SUBJECT: Coastside Design Review Recommendation
Cortez Avenue, Miramar
APN 048-032-070; County File No. PLN 2018-00397

At its meeting of April 11, 2019, the San Mateo County Coastside Design Review Committee (CDRC) considered your application for design review recommendation to allow construction of a new 1,732 sq. ft., two-story single-family residence, plus a 380 sq. ft. two-car attached garage, located on an existing 4,400 sq. ft. legal non-conforming parcel (legality confirmed via PLN2014-00116), as part of a hearing-level Coastal Development Permit (CDP) and a Non-Conforming Use Permit (UP). The Use Permit is required to allow development on a non-conforming parcel that proposes right and left side setbacks of 5 feet. and 7 feet., respectively, where 10 feet. is the minimum allowed for each side. No trees are proposed for removal. The Coastside Design Review Committee was unable to determine the findings for design review approval based on certain design deficiencies. In order to resolve these deficiencies in the project's design, a more thorough review of the "Standards for Design for One-Family and Two-Family Residential Development in the Midcoast" manual is required, with

LANDSCAPING Plan
 Designed by Leslie B. Wagle

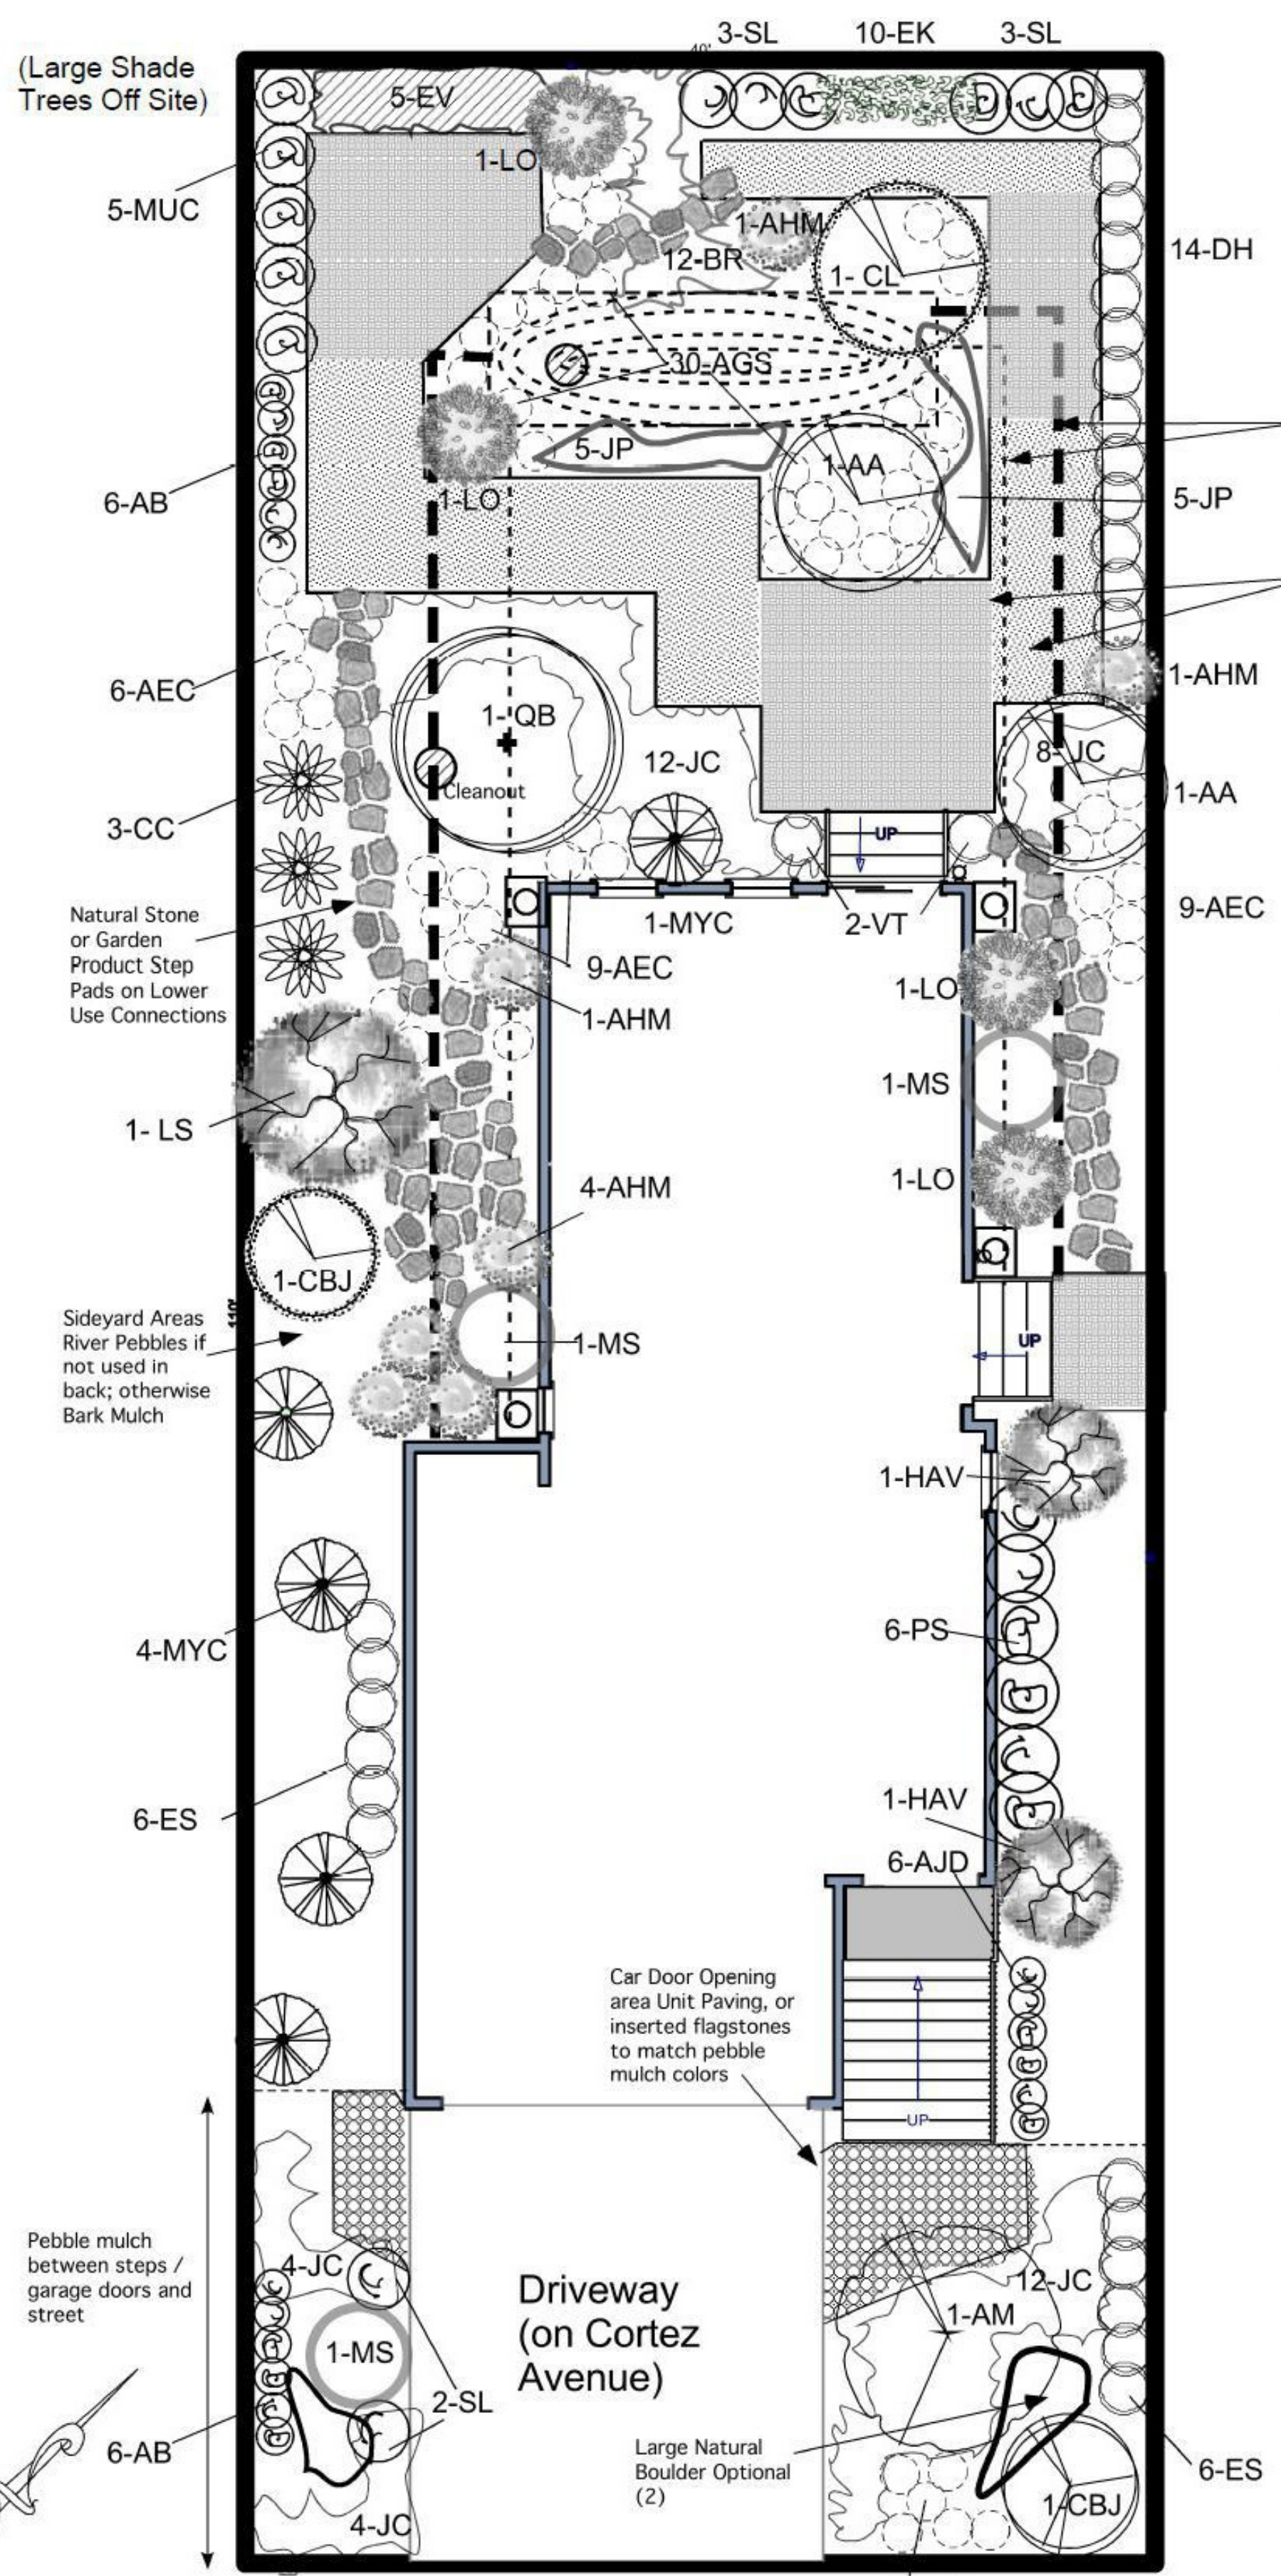
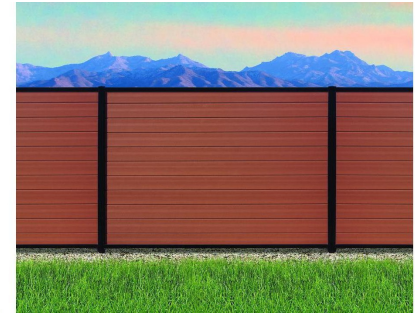
13. Upper level deck should be aesthetically subordinate to overall architectural style.
14. Group plantings for a more natural effect.
15. Incorporate a tree/plant species, plants that grow to a more substantial height and have longevity in a coastal zone, in the landscape plan. Roses are not recommended.

16. Replace and reduce concrete paving throughout the project. Replace with pervious material.
17. Reduce grass area significantly.

- Group plantings for a more natural effect.
Redesign: Landscape is now redone by a Landscape architect. We went over and make it really nice landscaping design. Groups of plants now introduce in the plan.

- Incorporate a tree/plant species, plants that grow to a more substantial height and have longevity in a coastal zone, in the landscape plan. Roses are not recommended.
Redesign: Landscape design is now done by landscape Architect. Adding tens of new plants to the plan by Landscape architect. Roses removed.

- Reduce grass area significantly.
Redesign: Grass removed from the plans. Landscape design is now redone by a Landscape architect.
- Recommendations (optional):**
